ANN ARBOR HISTORIC DISTRICT COMMISSION

Staff Report

ADDRESS: 301 South Main Street, Application Number HDC14-082

REPORT DATE: June 12, 2014

1 East Elevation
HDC-9 Scale: 3/32" = 1'-0"

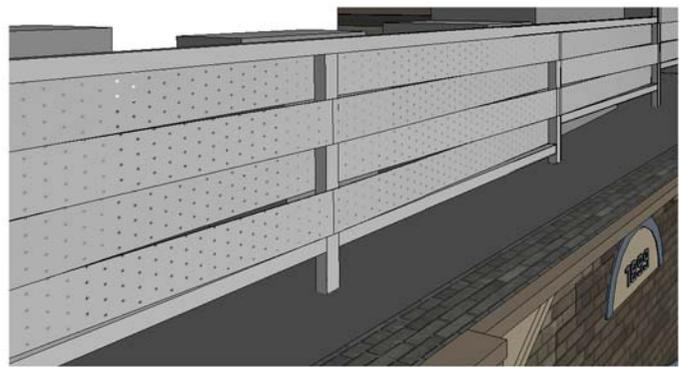
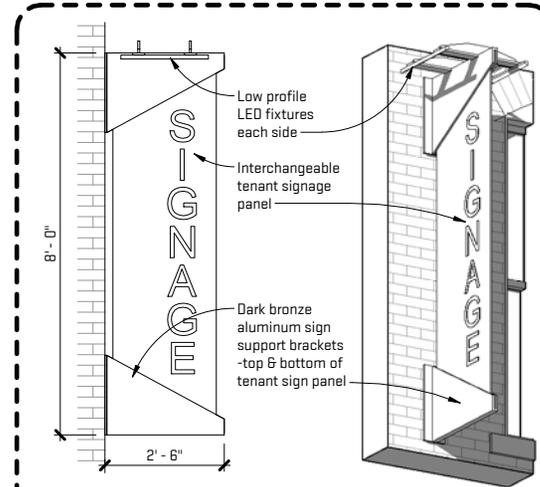
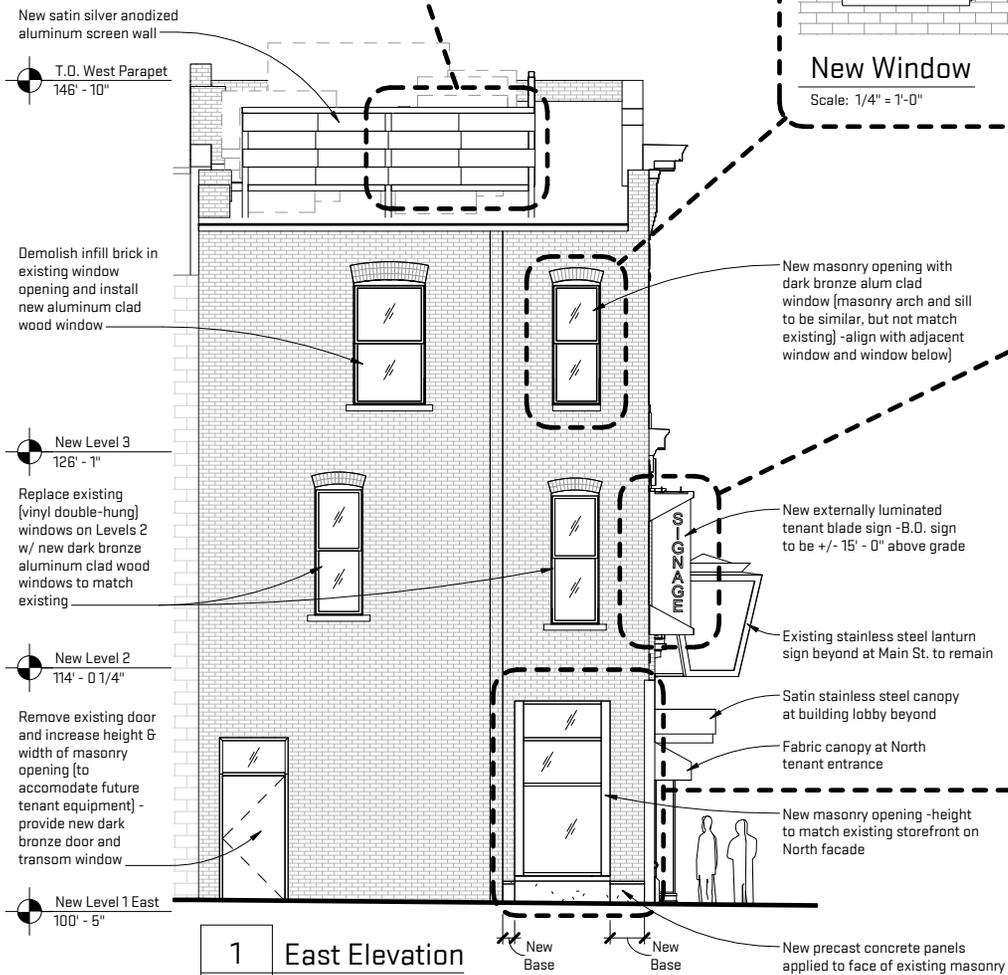
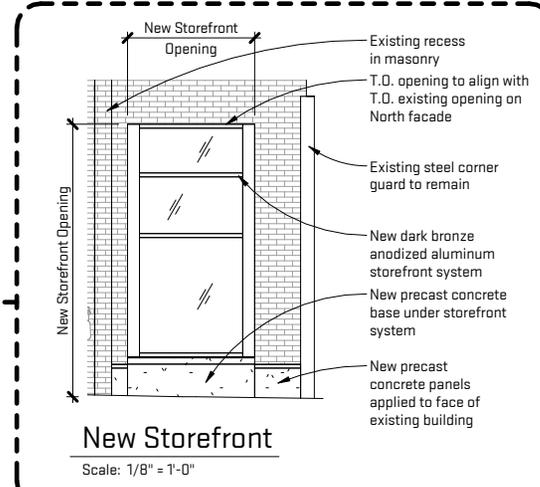
5. *East Façade.* The east façade currently contains a person-door and two presumably original window openings. Opening up the third floor bricked-in window opening and installing a new window is entirely appropriate. The installation of a new narrow third-floor window is appropriate since this is a secondary elevation, and the design of the window is traditional and complementary, but distinguished by a shorter stone sill and different brick arch pattern, both of which read as an addition to the building. The first floor masonry opening is correctly proportioned, located on a secondary elevation, and functional to draw light and attention to the ground level space. Removing the metal guards is completely appropriate.

7. *New Blade Sign.* Staff was initially hesitant about the blade sign proposed near the east corner of the building on the second floor. After looking at different signage options for this storefront, however, staff actually prefers it to a sign over the transom, which would be very high on the wall and not necessarily proportional. The blade sign matches the height of nearby windows. If additional signage is desired, staff suggests using lettering painted or applied to the inside of the storefront window. This or other additional signage would need to be approved by the HDC.

Roof New Work Plan

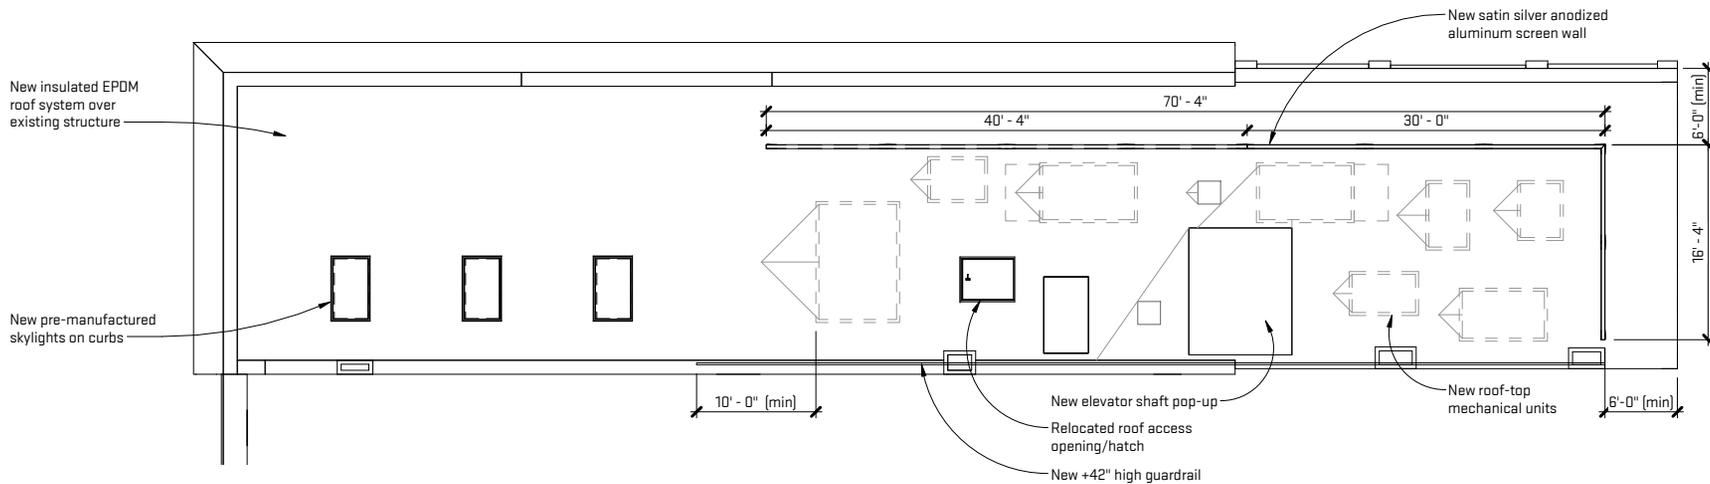
8. *Rooftop Mechanicals, etc.* The equipment, skylights, and elevator shaft proposed to be installed on the roof will not be visible from South Main Street. The proposed aluminium screening fence will be visible from across East Liberty. It is inset 6' from the face of the building, and appears to be around 5' tall. Staff prefers the cohesive look of a screening fence to the sight of a bunch of mechanical equipment. The light color will stand out less against the light sky than a darker fence would. It spans most of the East Liberty building, and the rear part of the larger South Main building.

Level 1 New Work Plan

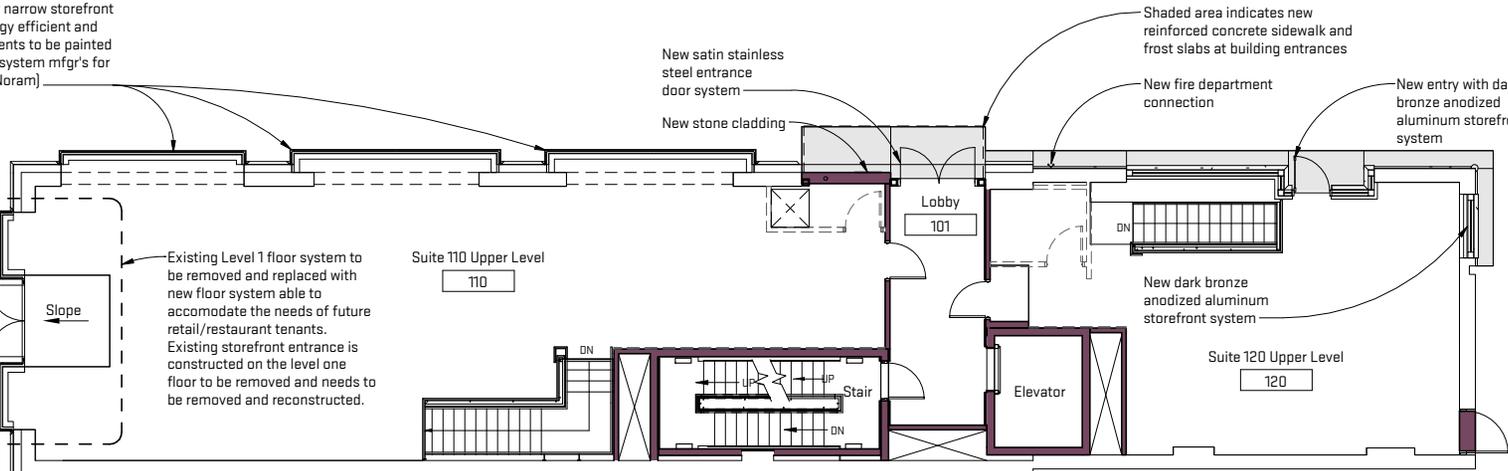
1. *Storefront Bays.* Staff is unsure when the storefront bays were constructed. The single-paned glazing is proposed to be replaced with an appropriate narrow, steel, double-paned system. Given the deteriorating condition of the bays, staff feels this work is

appropriate. (See application photos for deterioration documentation.) The inset storefront is proposed to be removed and pulled forward, and double-doors installed. This work is not appropriate unless it can be proved that the current inset was added outside of the period of significance, and that that configuration did not exist during the period of significance. See related discussion of plate glass transoms below.

Existing storefront bumpout to remain. Footprint of recess to be reconfigured to accommodate a pair of entrance doors in lieu of the existing single door

1 Building Lobby Canopy
HDC-12 Scale: 1/4" = 1'-0"

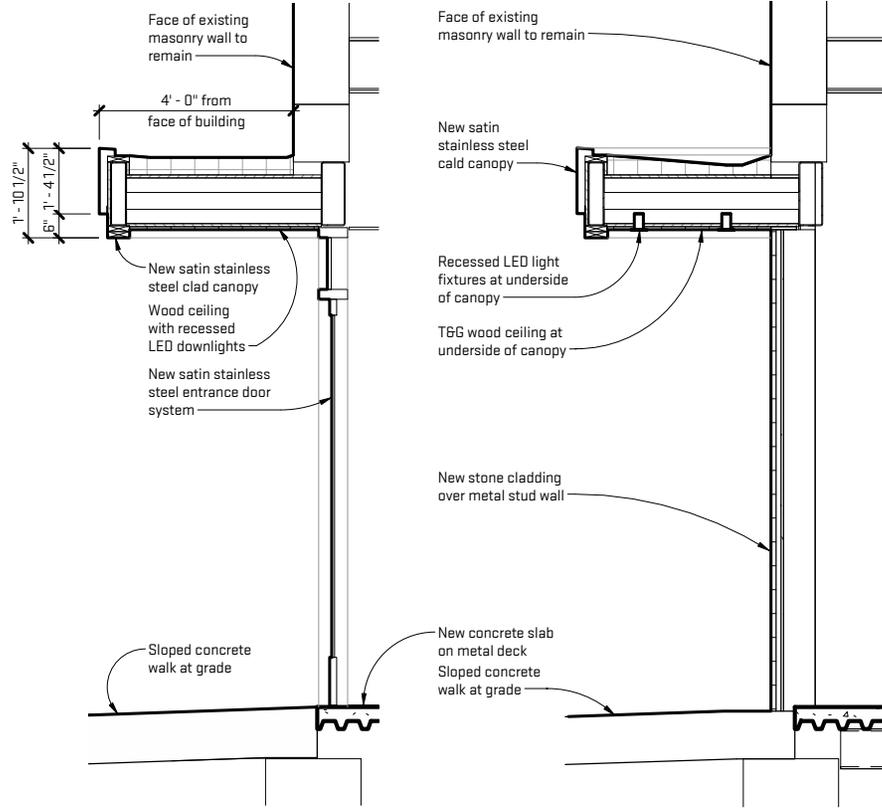
3. *North Lobby Entrance.* The existing lobby entrance off of East Liberty consists of an aluminum storefront system with a stone kickplate. The application proposes to infill half of the storefront with white polished stone, and widen the lobby doors from one to two. Also proposed is a satin stainless steel canopy, which would be 1'10" tall and span the width of the bay. The top of the canopy aligns with the top of the leaded-glass transoms. New lettering and tenant signage would be installed on the stone wall. Staff feels the new entrance is appropriate since it is a secondary entrance and clearly differentiated from the historic fabric of the building, yet intended to be complimentary.

1 Section at West Entry
HDC-13 Scale: 3/16" = 1'-0"

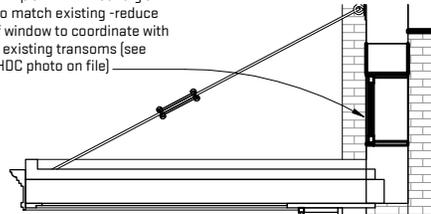
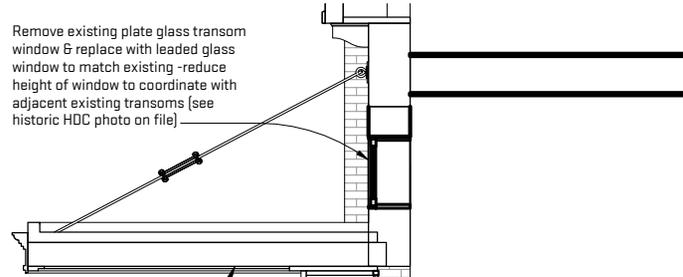
2. *Transoms.* The two leaded-glass transoms on the north elevation are proposed to be refurbished, with no material changes. This is appropriate work that does not require a Certificate of Appropriateness. The slightly larger plate-glass transom on the north elevation is proposed to be replaced with a leaded-glass transom to match the configuration of the other two. The installation date of this transom is unknown, though the 1908 photo at the end of this report shows an inset entry at the corner of Liberty and Main. When this corner was later boxed in and the columns removed, it is likely that the plate glass transoms were installed to span that corner space. The application references an HDC file photo that shows a leaded transom, but I've been unable to find that photo. Without it, staff feels that changing the transom would be inappropriately conjectural.

Remove existing plate glass transom window & replace with leaded glass window to match existing -reduce height of window to coordinate with adjacent existing transoms (see historic HDC photo on file)

Remove existing plate glass transom window & replace with leaded glass window to match existing -reduce height of window to coordinate with adjacent existing transoms (see historic HDC photo on file)

1 Section at East Tenant Storefront
HDC-14 Scale: 3/16" = 1'-0"

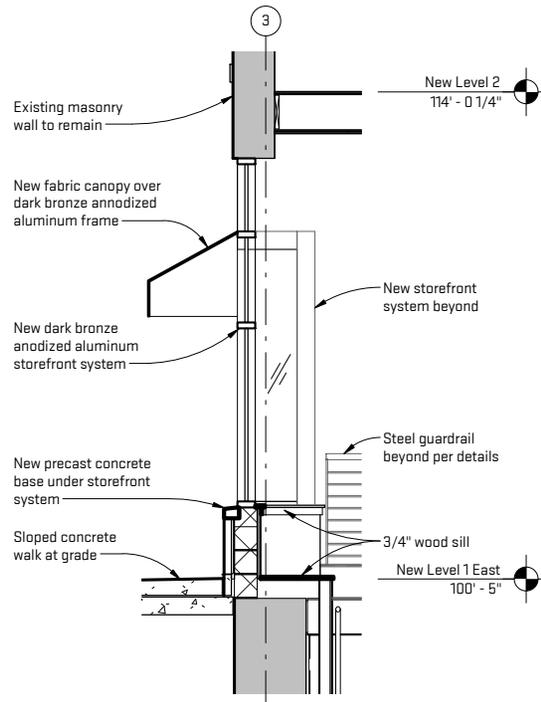
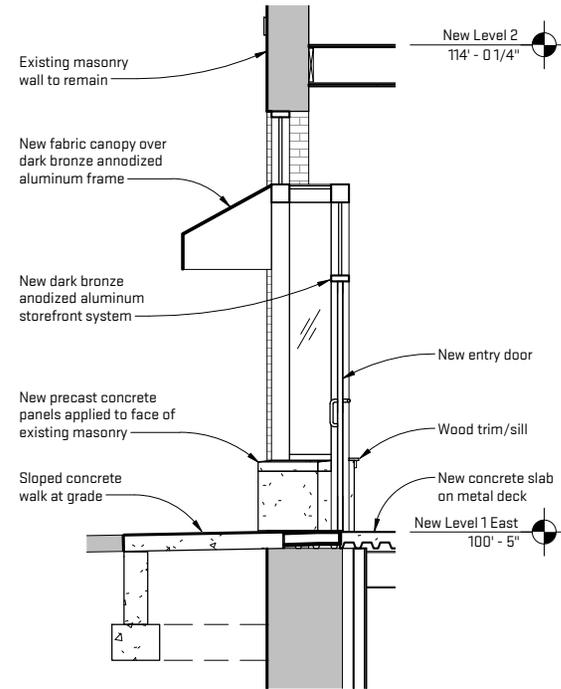
4. *Northeast Storefront.* The existing storefront is modern aluminum. Staff does not have photos of what this building looked like earlier than 1973 (which seems to show the same thing as today, minus a large round awning). The proposed new storefront is in the same opening, and is aluminum with a pre-cast concrete kickplate. Concrete panels are proposed to extend to the corners of the building on either side of the storefront. Given the extremely plain nature of the first floor of the building (which appears to have bricks of different ages, which could indicate infill of earlier storefront openings), and that the precast panels could be removed in the future, and that they will help differentiate this building from the larger one that it is attached to, staff finds these changes acceptable and an improvement on the current configuration.
